# Notice

### Information request

Reference: EA0002465 (Broadmeadow East Coal Mine)

The application reference number is: A-EA-AMD-100609123

Figure 5.1 Post-Closure Drawdown and Elevation for Rangal coal measures – 10-, 50-, 100- and 500-Years Post-C  
Figure 5.2 Post-Closure Drawdown and Elevation for Rewan – 10-, 50-, 100- and 500-Years Post-Closure

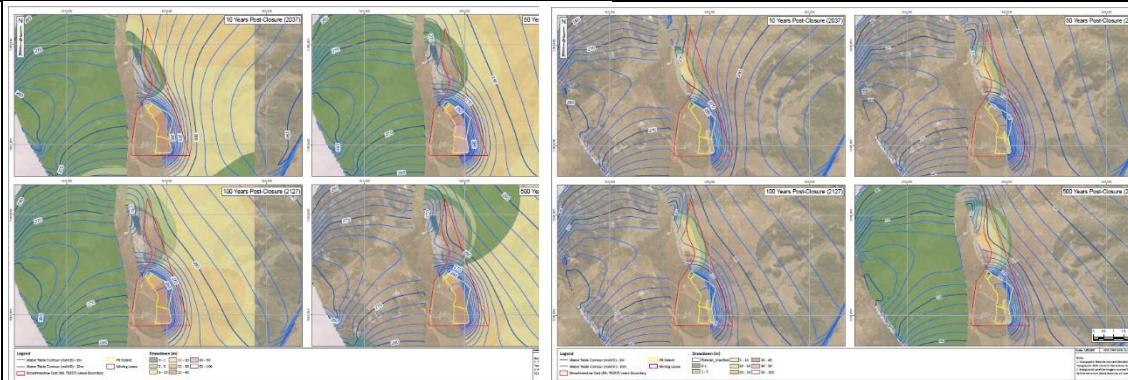
9	Additional drawdown contours	<i>Figure 5.1 Post-Closure Drawdown and Elevation for Rangal coal measures – 10-, 50-, 100- and 500-Years Post-Closure</i> and <i>Figure 5.2 Post-Closure Drawdown and Elevation for Rewan – 10-, 50-, 100- and 500-Years Post-Closure</i> (Appendix B Groundwater Report of the Supporting Document) provide predicted Post – Closure drawdown and elevation for the Rangal Coal Measures for 10, 50, 100 and 500 years post closure.	Provide –  (a) separate predicted drawdown contours for the Rangal Coal Measures for 10, 50, 100 and 500 years post closure with contour

The colour coding for the drawdown is difficult to interpret. It would be more informative if separate drawdown contour maps were provided with contour lines marked and labelled.

It is also noted that this document is to support the determination and validation of water level triggers. Predicted drawdown contours at the end of mining should be provided and for any other time period, where maximum drawdown is predicted to occur at the location of water level trigger bores. The predicted drawdown contours should be for the layers which the trigger water level bores are monitoring and have the location of the water level trigger bores marked clearly on the drawdown contour figures.

Additionally, it is noted in Figures 5.1 and 5.2 that the groundwater levels in the area of the Central and Northern pit are very slow to recover post mining.

Discussion of the processes assumed to be occurring that result in this outcome of slow post mining recovery of the Central and Northern Pits is required.

lines marked and labelled.

(b) predicted drawdown contours for the end of mining and for any other time period, where maximum drawdown is predicted to occur at the location of groundwater level trigger bores. The predicted drawdown contours should be for the layers which the groundwater trigger level bores are monitoring and have the location of the groundwater level trigger bores marked clearly on the drawdown contour figures.

(c) discussion of the processes assumed to be occurring that result in this outcome of slow post mining recovery of the Central and Northern Pits.

A water plot for this bore was provided in *Appendix B Groundwater Report, Appendix II Groundwater Elevations Hydrographs* (page 205). A copy is provided below.

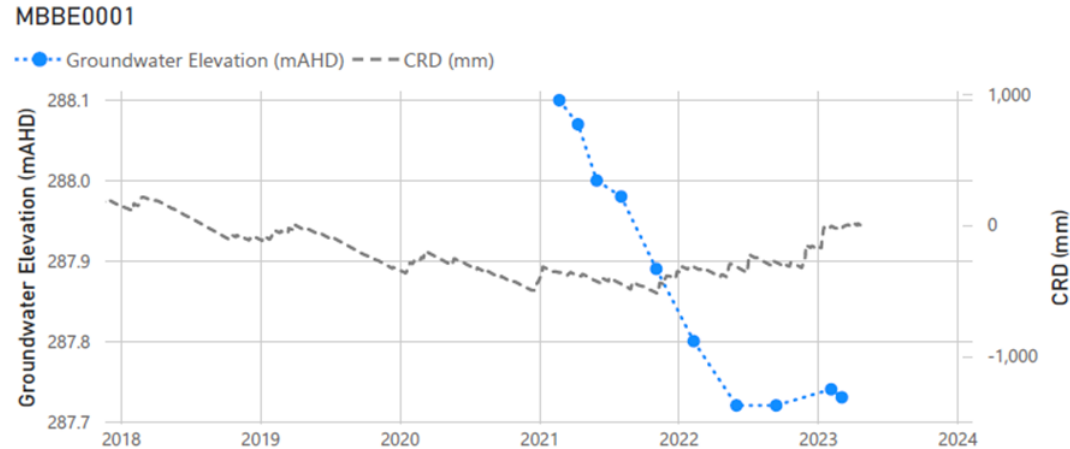
11	Comments on individual Bores	<p><b>MBBE0001</b></p> <p>This bore is screened between 63m and 66m below ground level (mbgl) (<i>Table 4.5 Updated Monitoring Bore Network Details and Monitoring Requirements Q1 2024</i> in Appendix D Update to Groundwater Quality Triggers Memorandum, KCB March 2024).</p> <p>Based on a ground level elevation of 305m AHD (Appendix B Groundwater Report Table 3.2 Groundwater Monitoring Network (KCB, Sept 2023)) the bottom of the screened interval is 239m AHD.</p> <p>However, the trigger level in the existing EA <i>Table D1 Groundwater Monitoring Locations and Frequency</i> and the proposed <i>Table D1</i> in Section 8.1.1 of the supporting document (<i>Table 8-1 Proposed new wording of Table D1</i>) is 206.01m AHD. The trigger level is therefore 33m below the bottom of the screened section of the bore and 32m below the bottom of the hole.</p> <p>Additionally, there is an issue with the baseline standing water level.</p>	<p>For bore MBBE0001, review and update were relevant:</p> <ul style="list-style-type: none"> <li>(a) the baseline standing water level.</li> <li>(b) the trigger water level.</li> </ul>

The baseline water level in *Appendix B Groundwater Report, Appendix I Monitoring Program, Table I-1 Groundwater Monitoring Bores at BME* is 42.2m below top of casing (mbtoc). Based on top of casing (TOC) elevation (EL) of 305.2m AHD (Appendix D Update to Groundwater Quality Triggers Memorandum (KCB March 2024)) this converts to a baseline water level elevation of 263m AHD. This does not seem to agree with the data above. It is unclear how the baseline water level of 42.2m was determined.
